ITEM 9. SECTION 96(2) APPLICATION: 106-116 EPSOM ROAD ZETLAND**FILE NO: D/2011/1760/B****DEVELOPMENT APPLICATION NO: D/2011/1760/B****SUMMARY**

Proposal Summary: The subject Section 96(2) application seeks to amend the Stage 1 DA approval for 5 building envelopes ranging from 5 to 14 storeys across the site, including basement car parking and public domain works to the subject site.

Figure 10: Buildings A - Building Volume comparison – additional envelope shown in dark grey and circled

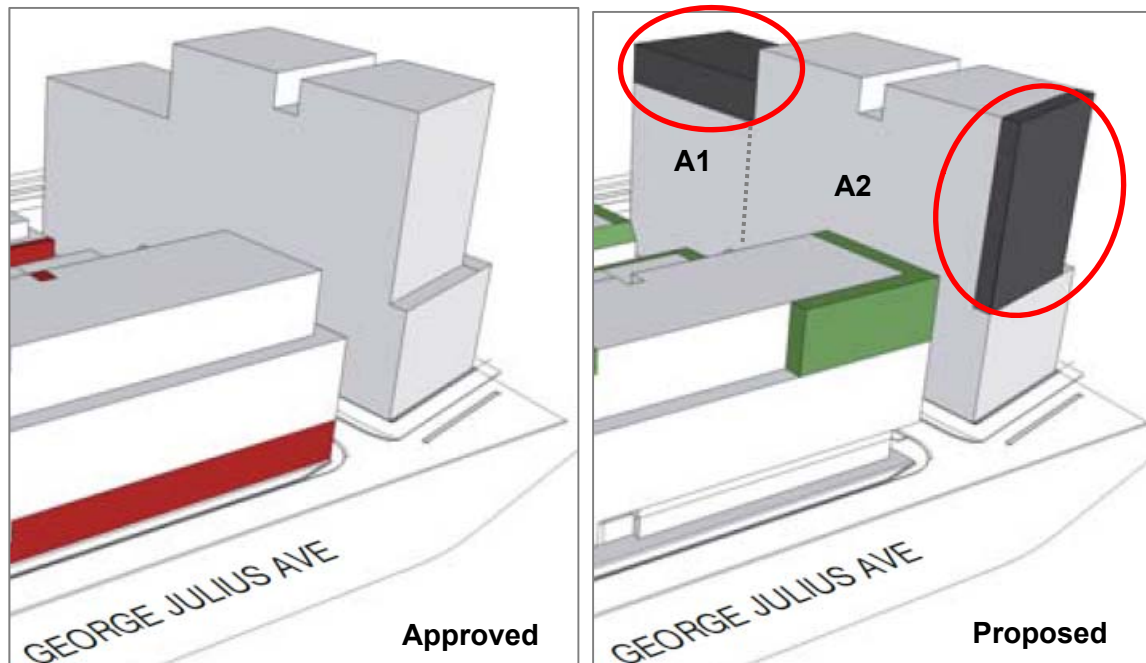
Amendment	Applicants submission	Assessment
Increase to the height of Building A1 from 10 to 12 storeys (Figure 10)	This will not create any significant additional overshadowing to the surrounding neighbours and will create a better height transition from Building A2 which is 14 storeys.	Supported - given the gaps between the 3 towers and through site link proposed in the stage 2 DA the increase in height is an acceptable 'transfer' of building mass, without any unreasonable overshadowing impacts.
Building A has been moved 1.4m further to the north	The built form of Building A has been moved 1.4m further to the north which is consistent with the 1.4m land dedication and proposed width of Rose Valley Way in the Sydney Development Control Plan 2012	Supported – the arrangement aligns with the DCP and current site conditions.

<p>The ground floor level to all street frontages has been recessed;</p>	<p>Reduces the bulk and scale of the development for pedestrians.</p>	<p>Supported – the recessed ground floors allow for architectural features, landscaping and visitor bike parking within the ground floor plane.</p>

Figure 11: Buildings B and C - Building Volume comparison

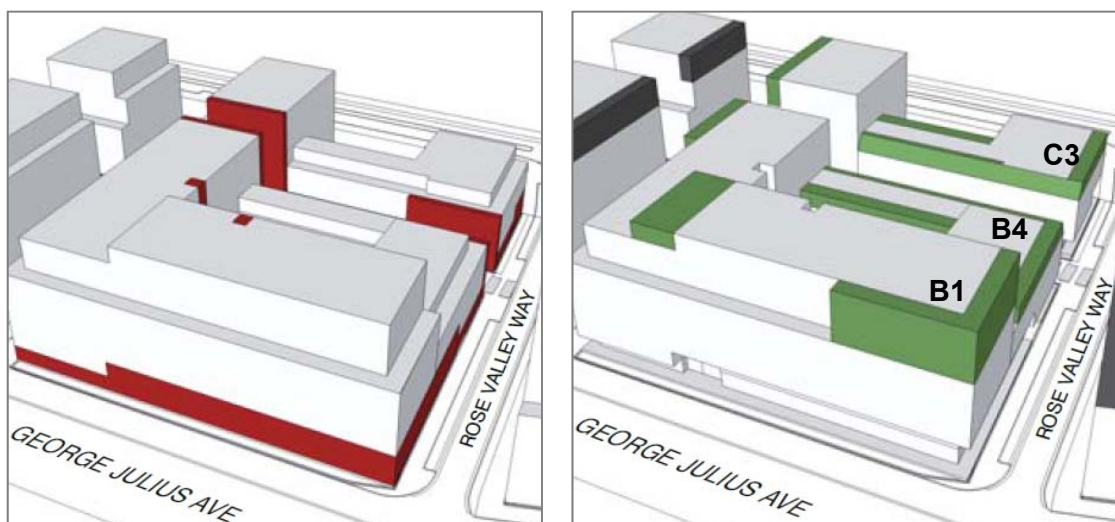
Amendment	Applicants submission	Assessment
The ground floor to floor height has been increased to 4.6m and the floor to floor heights of the upper levels have been increased to 3.1m;		Supported – the increase in heights improve overall amenity of units.
B1 – 3m setback above level 6 to George Julius Avenue and Rose Valley Way has been reduced to 0m on this corner (Figure 11)	The upper levels are to be built to the corner of the George Julius Avenue and Rose Valley Way which is consistent with built form to Building A2 and defines the street corner. It is further noted that the ground and first floors of Building B1 are recessed which creates a pedestrian scale of development;	Supported - this arrangement was part of the architectural design winning scheme and is an appropriate form for this corner.
B4 and C3 - 3m setbacks above level 3 reduced to 0m (Figure 11)	The nil setback to the corners of Rose Valley and Letitia Street for Buildings B4 and C3 assists in defining the entry into Letitia Street;	Supported - this arrangement was part of the architectural design winning scheme and is an appropriate form for streets, the increased ground floor setbacks enhance the pedestrian scale at the ground plane.

Figure 12: Buildings B and C - Building Volume comparison

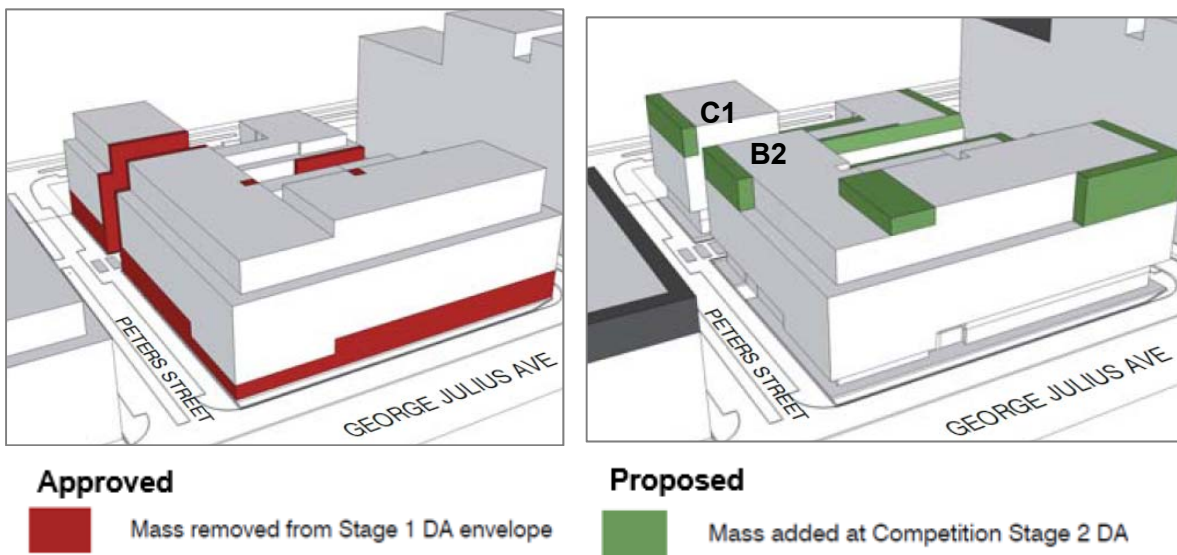
Amendment	Applicants submission	Assessment
B2 and C1 - 3m setback above level 6 to Peters Street is reduced to 0m (Figure 12)	Only one of the upper levels of Building B2 is setback to the George Julius Avenue and Peters Street however the built form generally defines the street edge and it is noted in the Stage 2 DA that the upper level incorporates light coloured transparent shade elements which reduce the appearance of bulk and scale. The nil setback to the corners of Peters Street and Letitia Street for Buildings B2 and C1 assists in defining the entry into Letitia Street.	Supported - this arrangement was part of the architectural design winning scheme and is an appropriate form for these corners.
The ground floor first floor levels have been recessed from all street frontages;	The recessed ground and first floor conditions will allow for landscaping opportunities and creates a pedestrian scale of development.	Supported.

Part of Building B2 has been increased from 8 to 9 storeys (Figure 12)	Building B2 has been partially increased from 8 to 9 storeys along George Julius Avenue. The partial height increase to Building B2 allows for a continuous building line along the George Julius Avenue while it is noted the built form is recessed from the building edge. The additional height will not create any further amenity impacts to surrounding neighbours while it is acknowledged that the future residential accommodation will have high level of amenity with pleasant views to Gunyama Park and western aspects. Furthermore, the Stage 2 DA details the materials to be incorporated which are light coloured perforated panels which reduces the appearance of bulk and scale.	Supported - The partial height increase allows for a continuous 9 storey building line along the George Julius Avenue. The additional storey is recessed from Peters Street and incorporates light coloured panels which reduces the appearance of bulk and scale. The additional height will not result in any overshadowing or other amenity impacts and is acceptable.

Figure 13: Building D - Building Volume comparison – approved Stage 1 envelope shown in red dashed line

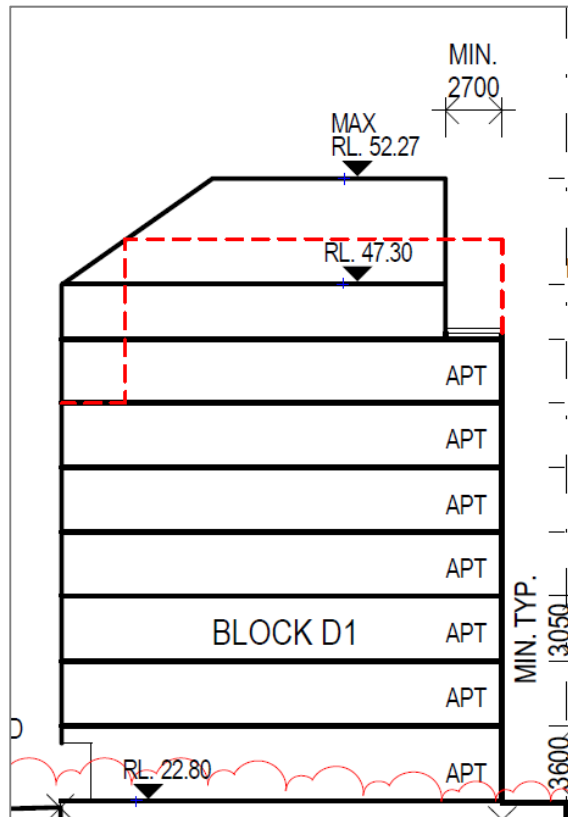
Amendment	Applicants submission	Assessment
A setback has been introduced to ground floor and level 1 along Letitia Street and to ground floor along Peters Street.	The recessed ground and first floor conditions will allow for landscaping opportunities and creates a pedestrian scale of development.	Supported.
Increase to the height of Building D1-D2 by 7m (saw tooth roof);	This is a result of a varied roof form, which incorporates a saw tooth arrangement, which provides a unique but interesting built form to the northern edge of the development site.	Supported - This roof form was part of the architectural design winning scheme and is an appropriate form.
The upper level setbacks have been reduced along Peters Street and George Julius Avenue (Figure 13)	The nil setback to Peters Street defines the street edge and it is noted that the roof form to the southern elevation is angled down towards Buildings B and C to increase the solar access to the northern façade of B and C.	Supported - This roof form was part of the architectural design winning scheme and maintains an acceptable street interface.

Figure 14: Building D - Building Volume comparison - approved Stage 1 envelope shown in red dashed line

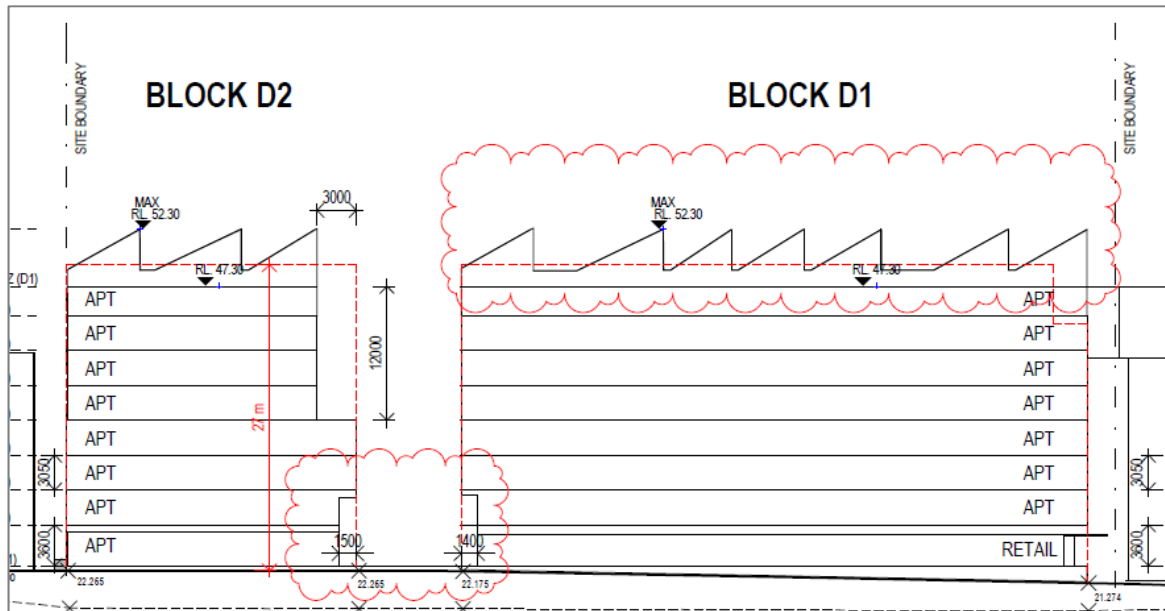
Building D2 has been setback a further 3.6m along Letitia Street from Level 6 and above (Figure 14)	The proposal introduces a 4m setback to the upper 2 levels along Letitia Street to Building D2, which was not required by the Stage 1 DA however it reduces the built form to Letitia Street.	Supported.
